**Comanche Peak Nuclear Power Plant, Units 3 & 4
COL Application**

**Part 2, FSAR
Update Tracking Report**

**Revision 7
(Non-Security Related Version)**

Figure 10.4.5-1R Circulating Water System Piping and Instrumentation Diagram

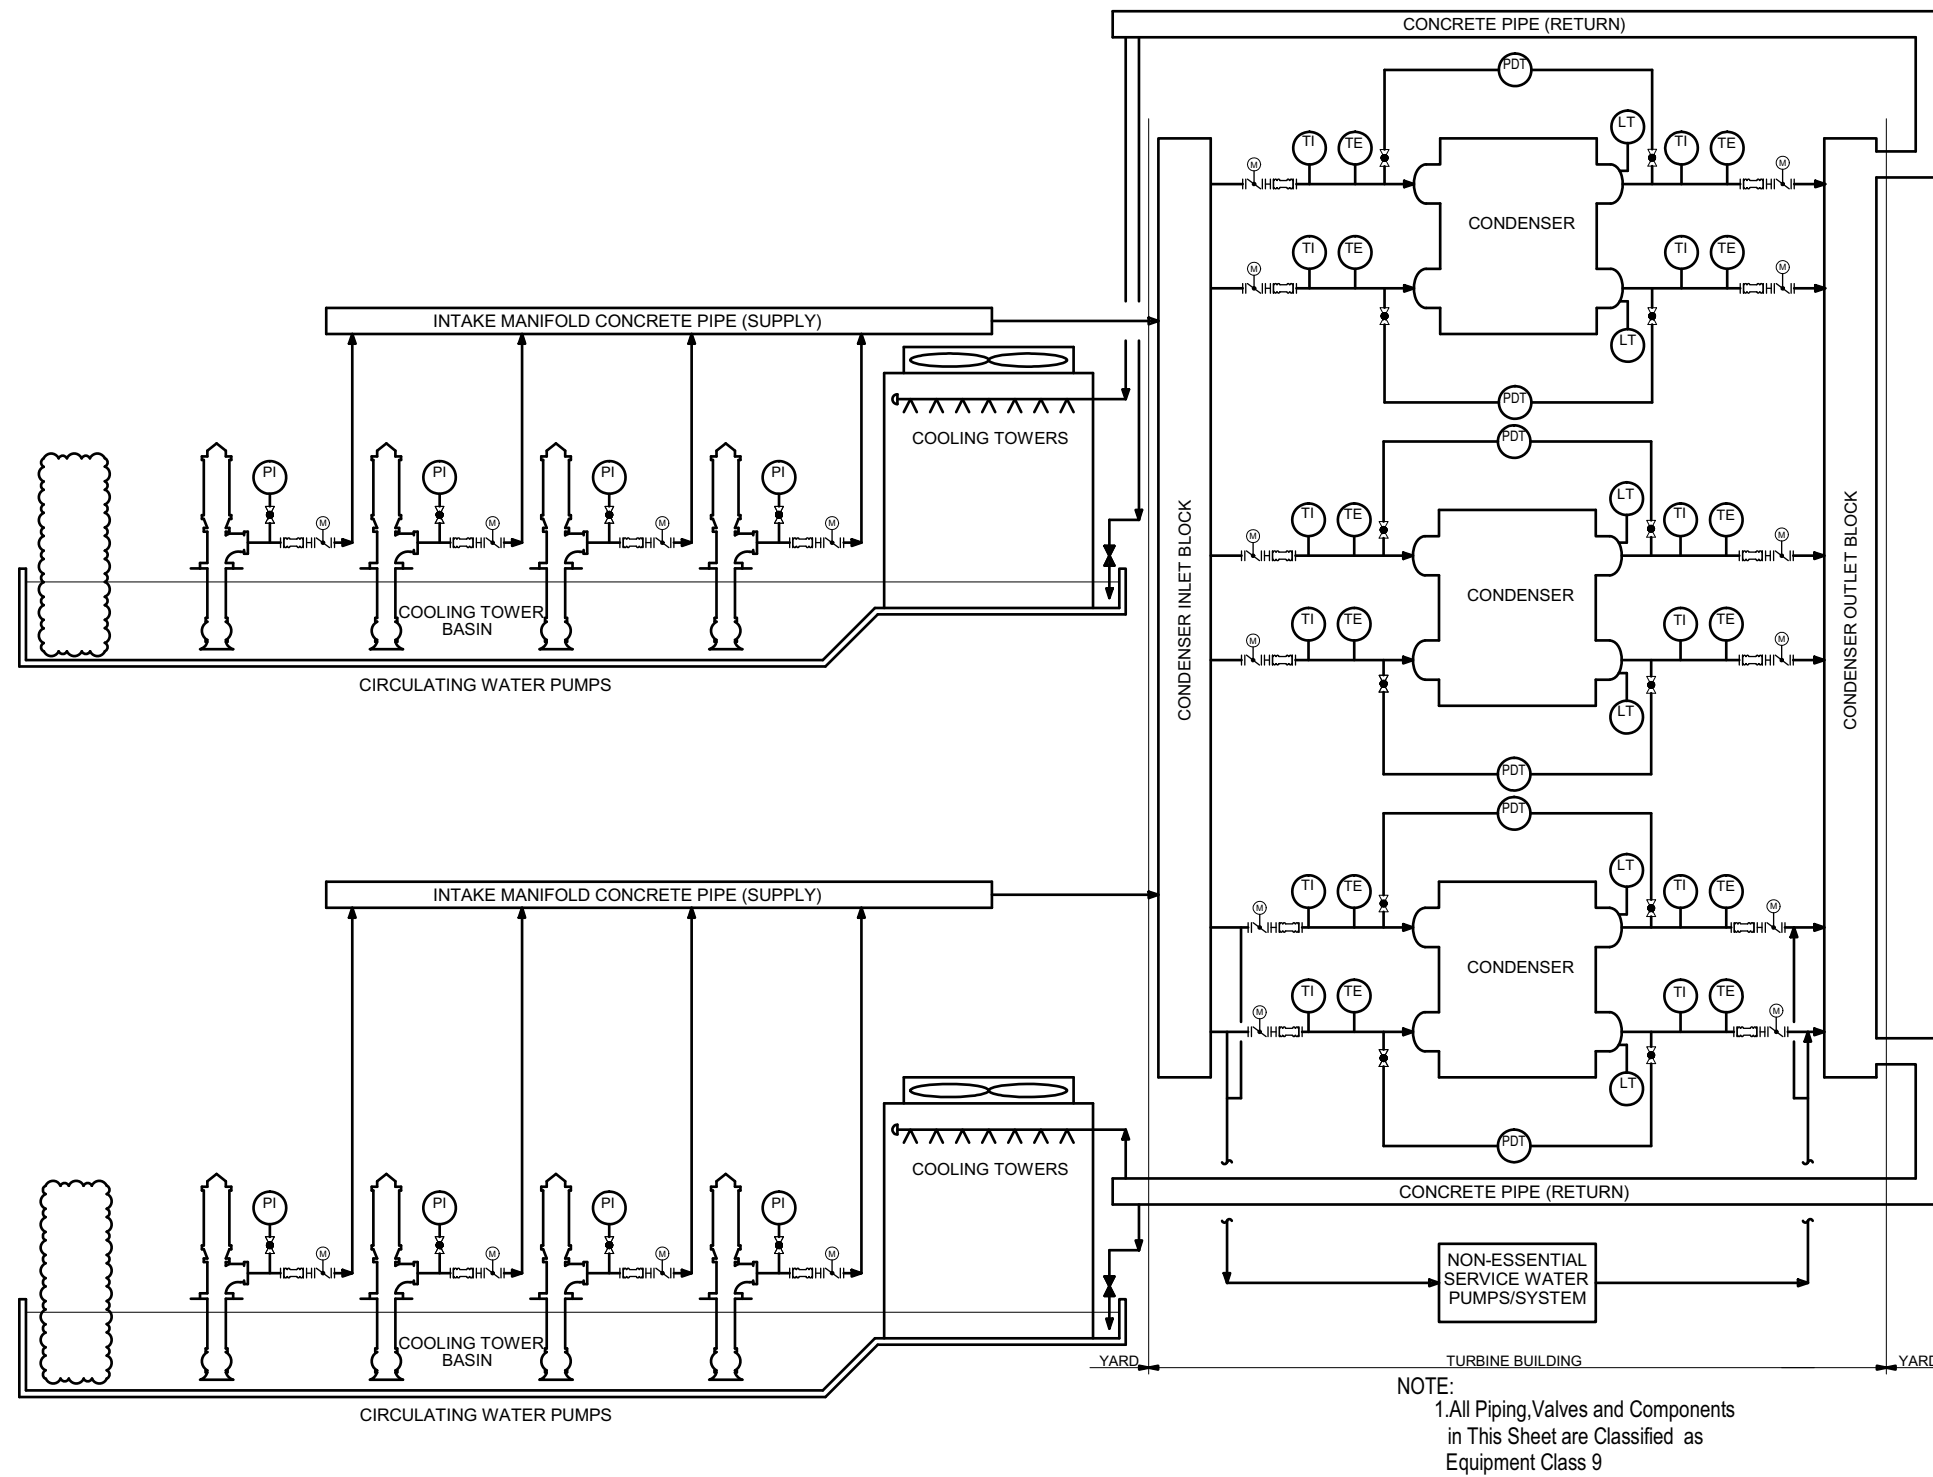
Change ID No.	Section	FSAR Rev. 0 Page	Reason for change	Change Summary	Rev. of FSAR T/R
MAP-10-101	Figure 10.4.5-1R	10.4-16	DCD Change	Change equipment class of the system from 5 to 9.	7
MAP-10-102	Figure 10.4.5-201	10.4-17	DCD Change	Change equipment class of the system from 5 to 9.	7
MAP-10-103	Figure 10.4.8-1R	10.4-18	DCD Change	Clarify building boundary. Change equipment class. Change equipment number. Add equipment class in vent line from SGBD flash tank and in SGBD cooling water line.	7
MAP-10-104	Figure 10.4.8-2R	10.4-19	DCD Change	Clarify building boundary. Added instruments in the line from demineralized water. Change equipment name from "ION CHROMATOGRAPHY" to "BLOWDOWN SAMPLE STATION". Change equipment class in the lines from SGBD cation/mixed bed demineralizer and the lines of SGBD demineralizers inlet filter.	7
MAP-10-105	Figure 10.4.8-201	10.4-20	DCD Change	Add equipment class.	7

Figure 11.4-201 Solid Waste Management System Piping and Instrumentation Diagram

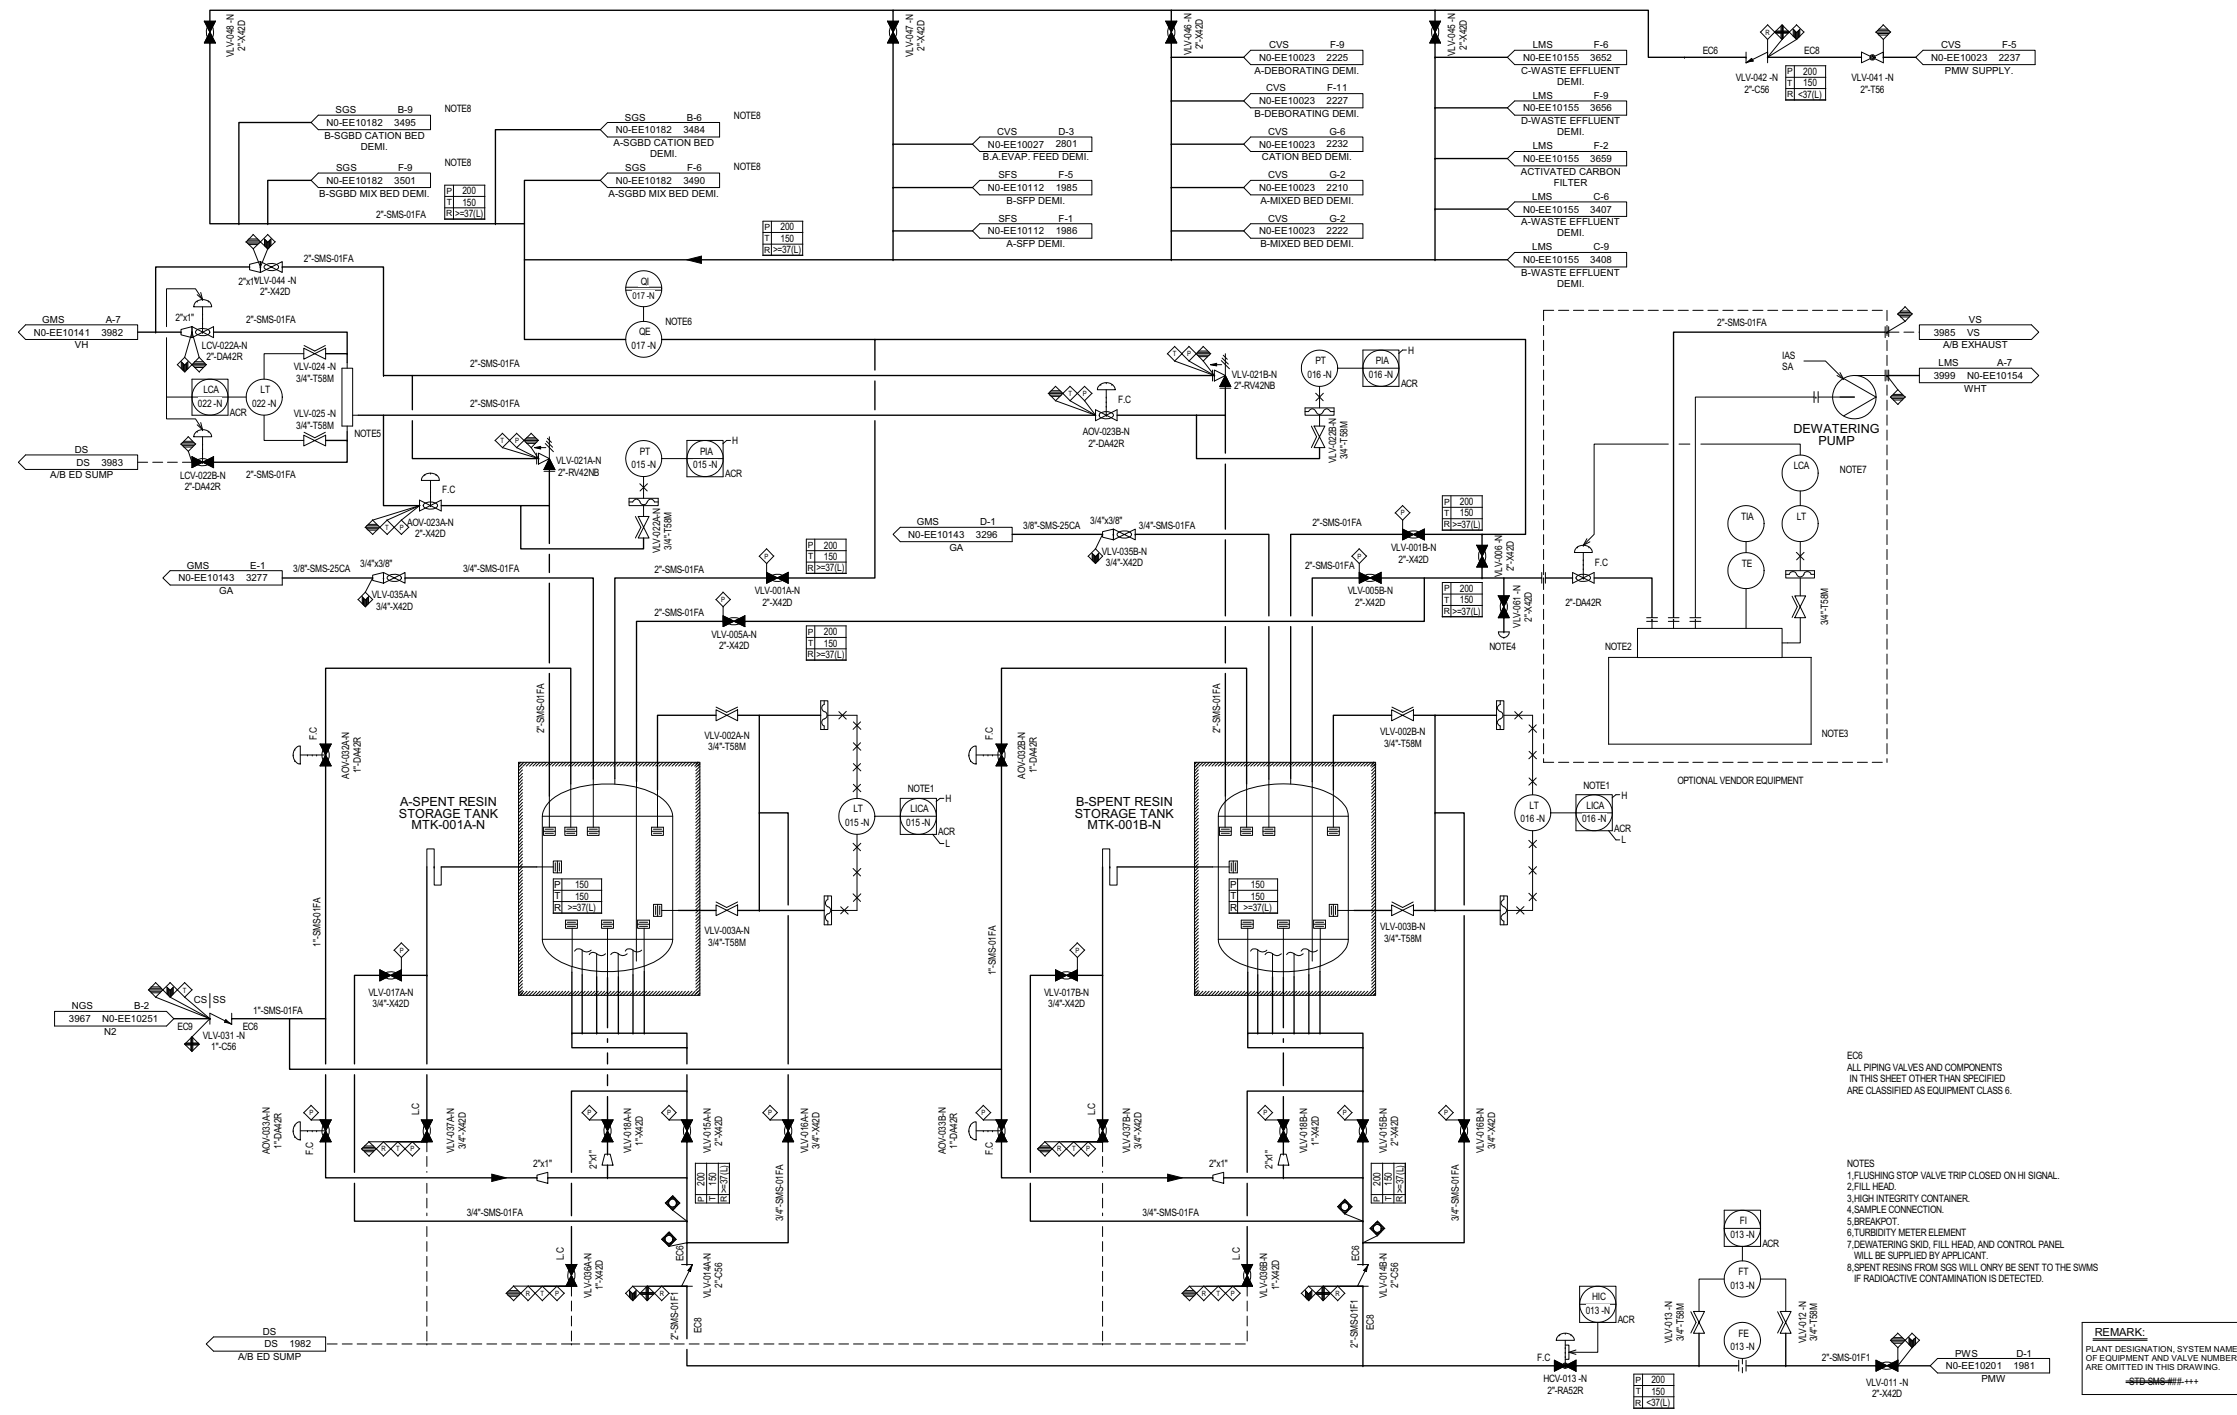
MAP-11-107	Figure 11.4-201	11.4-6	DCD change due to US-APWR design revision	Update figures to reflect the changes of standard design. The changes include reflection of piping arrangement information.	7

Figure 12.3-1R Radiation Zones for Normal Operation/Shutdown Site (Sheet 1 of 34)

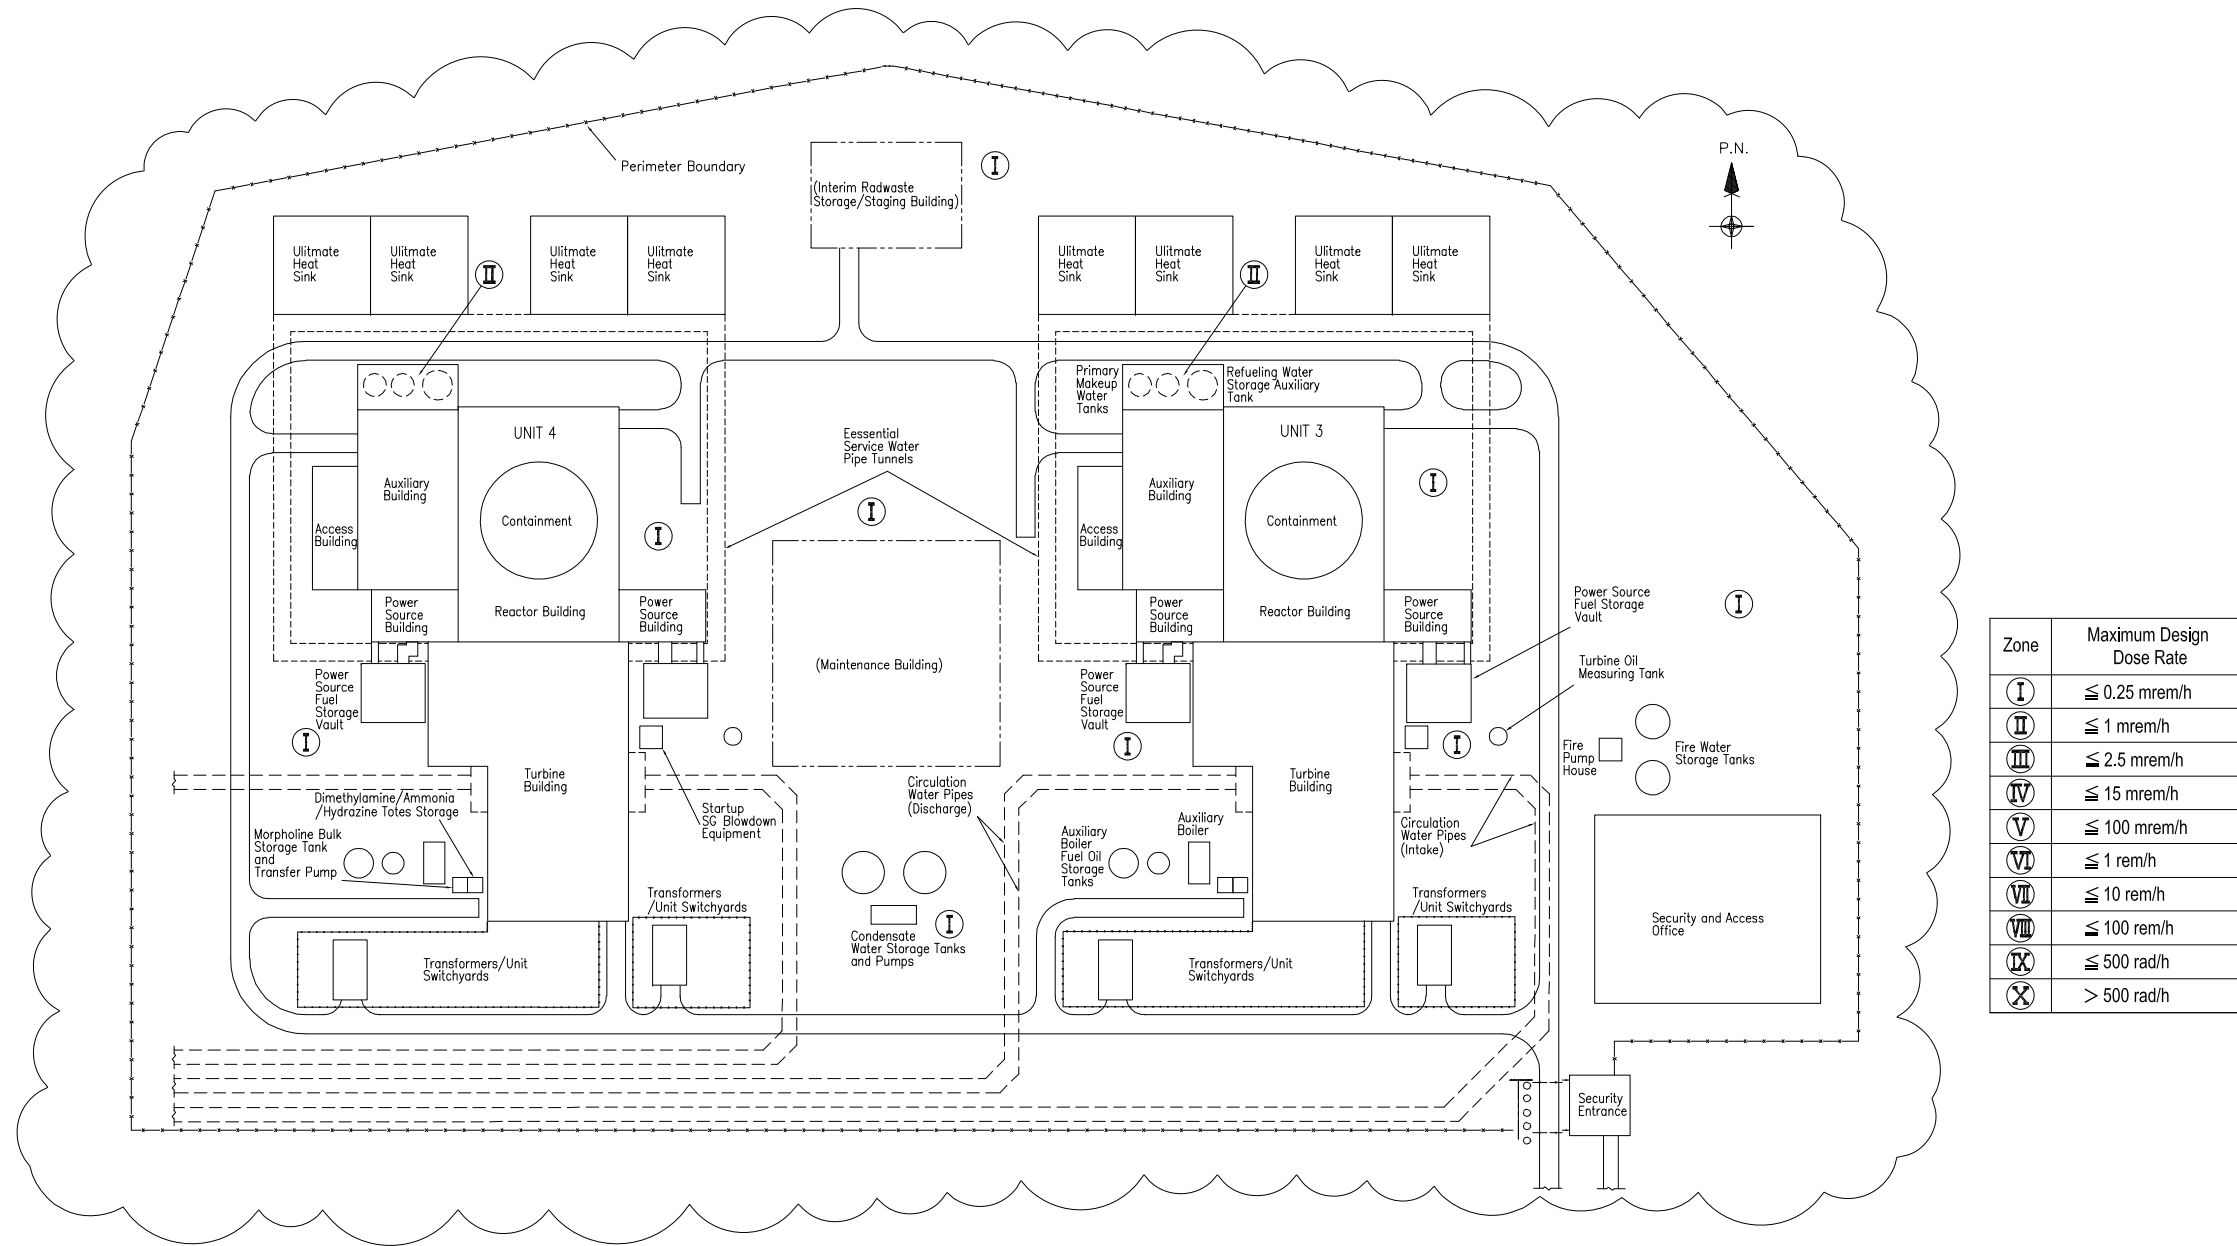
MAP-12-101	Figure 12.3-1R	12.3-3	Consistent with DCD Rev.2	Replace the figure to Reflect layout change.	7
CTS-00879	12.5	12.5-1	Editorial	Version of NEI 07-08 is revised from 1 to 3.	7
